Submissions to BSCPP 15/004 Greenwood Place

Re: Planning Proposal – BSCPP 15/004, Greenwood Place, Lennox Head

Re: Planning Proposal BSCPP 15/004 – Greenwood Place, Lennox Head

Image above: view from back deck and proximity to children's play equipment overlooking subject land

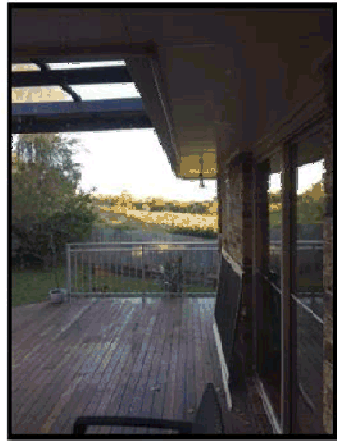
This statement again fails to consider houses adjoining the subject land. Our home, for example, has a backyard adjoining the subject development, and our back deck overlooks this land. In the interest of providing a comprehensive report on the visual assessment of the proposal, please find following a photo taken from our kitchen window and back deck. This image clearly demonstrates our property overlooks the subject planning proposal, in close proximity to our home, and will have a detrimental impact to our visual amenity. It will also negatively impact on our children's ability to play safely in their backyard whilst construction of the development is underway.
